AGENDA

PLANNING AND ZONING COMMISSION

January 19, 2016 - Tuesday

**Figure 2
Removal Activity Map**

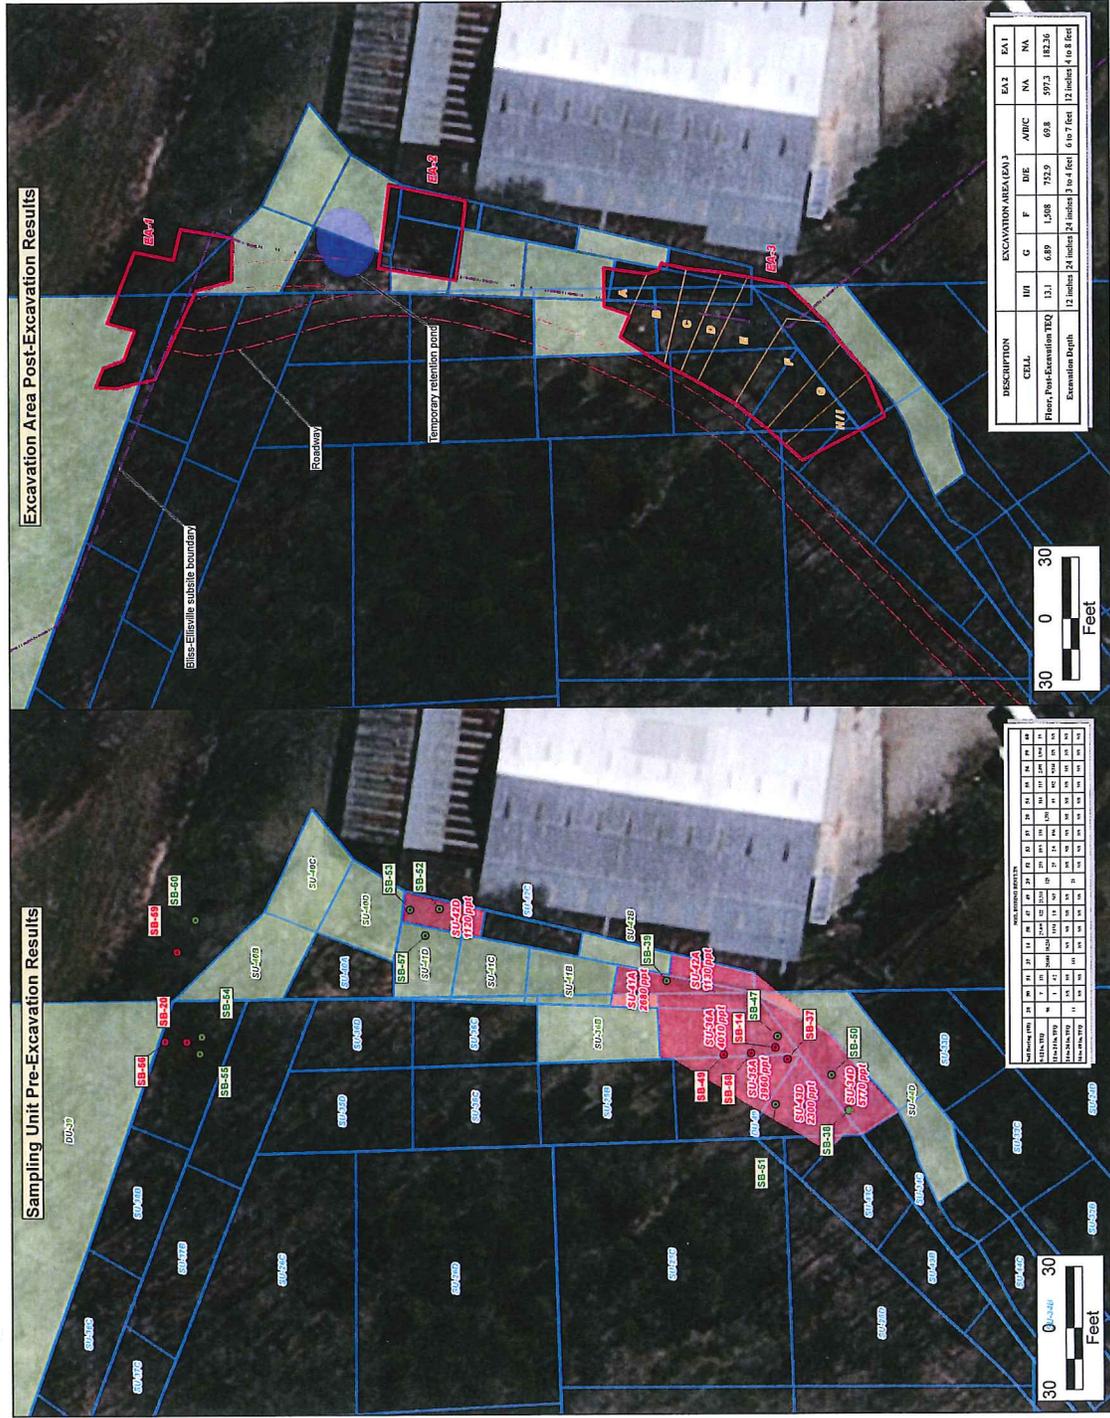
- g. **Fig. 2 Pre-Excavation**
i. **Please add a triangle illustrating EA-1.**
ii. **Soil Boring table is illegible.**

- g. Fig. 2 Pre-Excavation
 - i. Please add a triangle illustrating EA-1.
 - ii. Soil Boring table is illegible.
 - h. Fig. 2 Post-Excavation
 - i. Please illustrate NPL line in bright color.

- ii. Please add the 4 cell letters to EA-2.
 - iii. Please clarify EA-1 with Table 3 since it's an odd shape with 4 north walls.
 - i. Fig. 3
 - i. Please illustrate NPL line in bright color.
